Summerlin Village 25 Grand Park Boulevard Improvements
- Street "M" to Fox Hill Drive

CITY OF LAS VEGAS		DATE:
INTER-OFFICE MEMORANDUM		December 23, 2020
TO: Land Development Services Department of Building & Safety		FROM: Albert Sung, P.E. Flood Control Project Engineer Department of Public Works
SUBJECT: Drainage Study for: Summerlin Village 25 Grand Park Boulevard Improvements - Street "M" to Fox Hill Drive		COPIES TO: GCW Inc.
Cross Streets:	Grand Park Boulevard & Redpoint Drive	Howard Hughes Company, LLC
File Number:	F:\Depot\DSMemos\DS5219C.doc	Bart Anderson, P.E., DevCo
Parcel Number:	137-22-101-001	CCRFC
Zoning Action:	N/A	
FEMA Flood Zone	YES NO X	
Proposed Storm Drain	YES X NO

**DISTRICT CONCURRENCE: VILLAGE 25 GRAND PARK BOULEVARD IMPROVEMENTS
(STREET 'M' TO FOX HILL DR)
(DS5219B) (RFC No. 20-13673)**

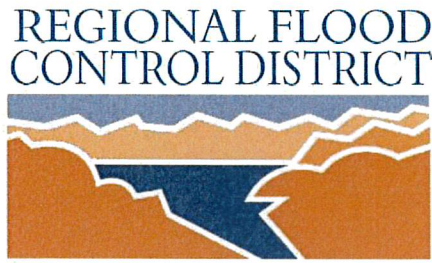
- The project proposed to construct temporary drainage facilities including drainage berms/ditches along the west side of *Grand Park Boulevard*. Prior to the final plans approval, the developer must complete a **Maintenance & Liability Agreement** for the interim drainage improvements and post a minimum maintenance bond of \$50,000 or 50-percent of the construction cost for the improvements, whichever is greater. The engineer must submit an estimate of the quantities for constructing the facilities and an exhibit that adequately shows the location and limits of the drainage facilities to *City Flood Control* for approval. Once the drainage study is conditionally approved, the engineer/developer should contact the *City's Land Development Section* (702-229-6371) to begin the agreement process.

In order for the maintenance bond to be released in the future, a drainage update/letter will be required to justify that the berm/swale are no longer necessary and can be removed.
